SAMPLER CARD

FIELD CHANGE NOTICE

ASSEMBLY No. ESP-348

DESCRIPTION Sampler Card

Fairlight ESP	
30 Bay St., Broadview, 2007	
Designed: C.E. Alfred	
Title: AES REPLACEMENT WIRING DIAGRAM	
Size: A	Document Number: PEV
Date: April 7, 1993	Sheet 1 of 1

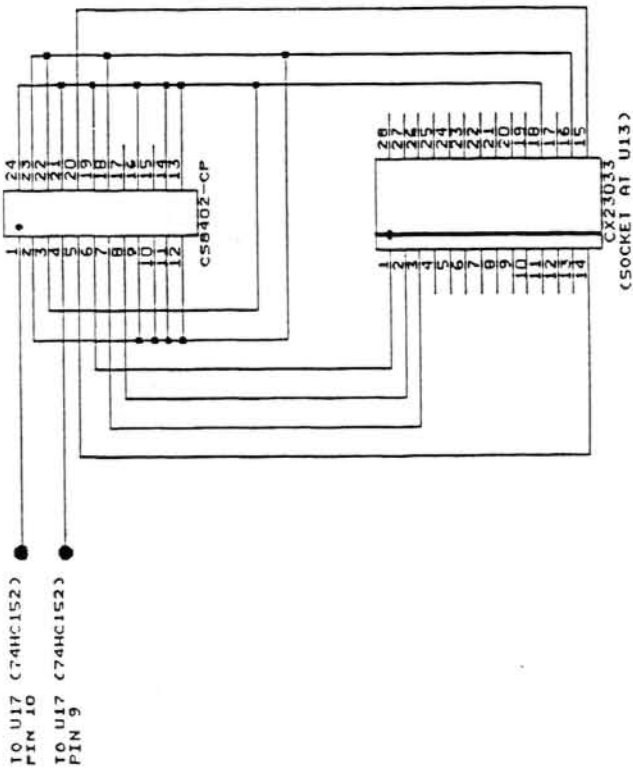
Due to the change in specifications of the AES / EBU standard the digital output chip used on the sampler is obsolete.

The addition of this new chip will output full AES with pro bit set and sample rate bit set.

1. Remove Sony chip from socket. (CX23033) at U13. Do not remove the socket.
2. Plug in ESP-350 AES adapter pcb assembly.
3. Wire pin 1 of the Crystal CS8402-CP to pin 10 U17 (74HC152).
4. Wire pin 4 of the Crystal CS8402-CP to pin 9 U17 (74HC152).
5. Cut track at U13 pin 3.
6. Wire U13 pin 3 to U6 pin 2.
7. Label board REV 1.8

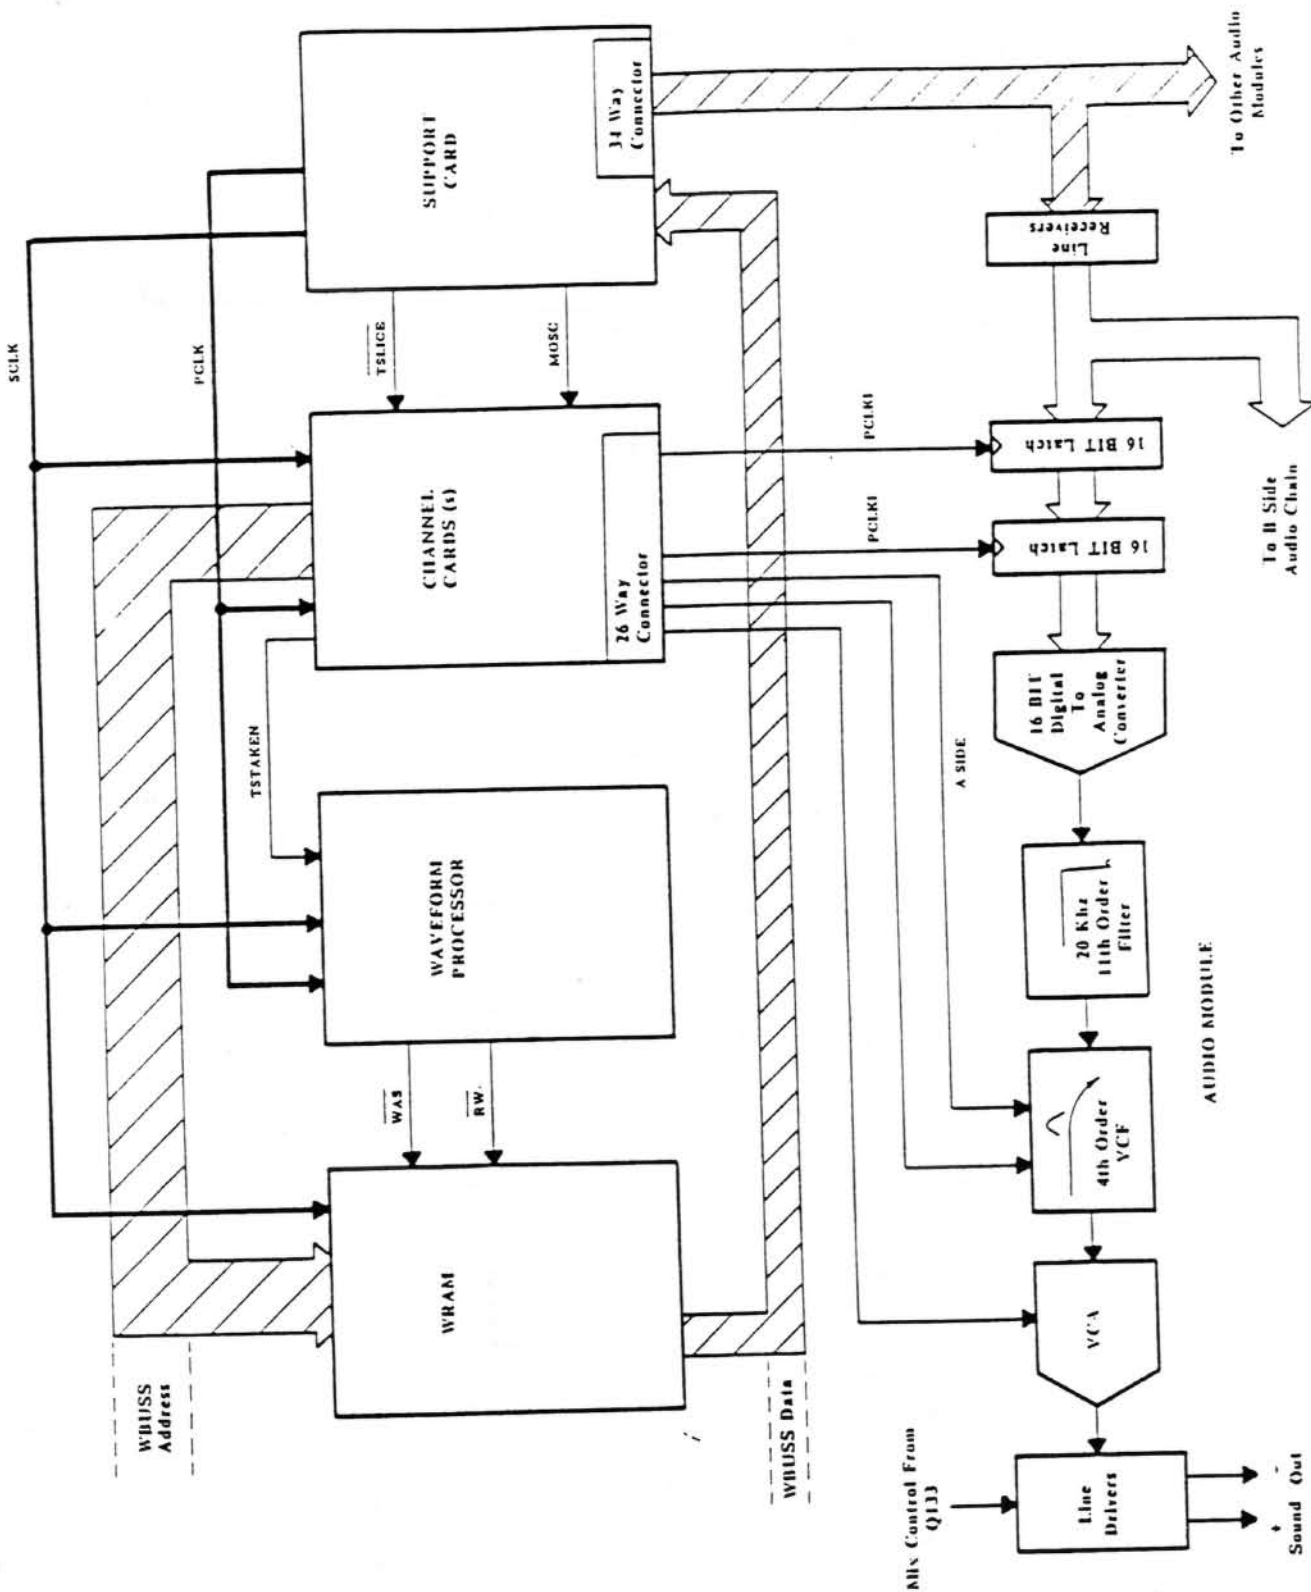
To increase the analog input sensitivity such that a signal of +4dbm corresponds to a full scale reading on the sample page meters.

- 1) For Sample cards which have the Digital and Analog boards joined by a ribbon cable. Resistors R23 & R24 and R34 & R35 original value was 10k new value is 2.0k 1% See attached overlay.
- 2) For Sample cards which have the Digital and Analog boards joined by a connector set. Resistors R24 & R25 and R34 & R35 original value was 10k new value is 2.0k 1% See attached overlay.

Title		Series III Sampler Interface
Size Document Number		A
Date		August 2, 1991 Sheet 1 of 1
REV		1

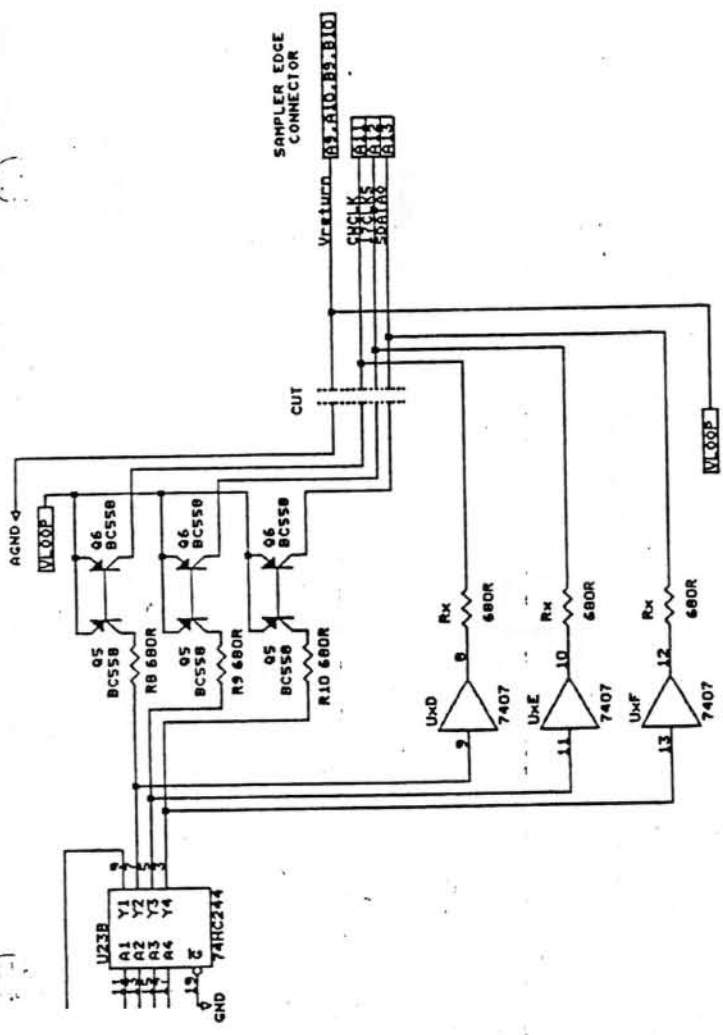
05.08.1991 ces: 7407/680R current loop
Fairlight ESP P/L

10 MAY SAMPLER
INTERFACE CONNECTOR

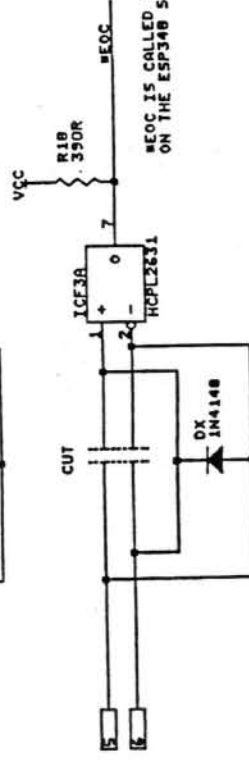
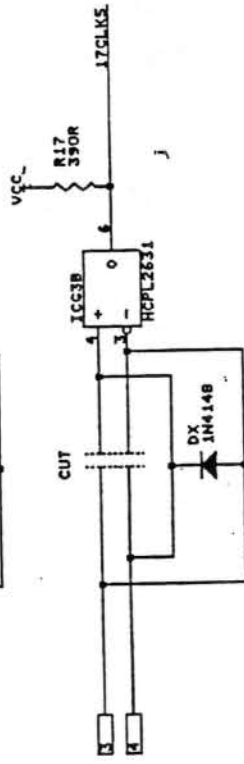
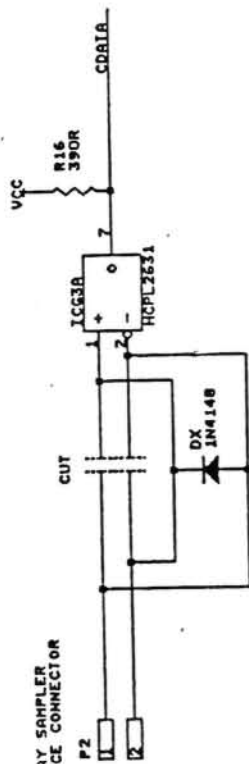
05.08.1991 cast reversed OPTO inputs
added reverse biased diodes
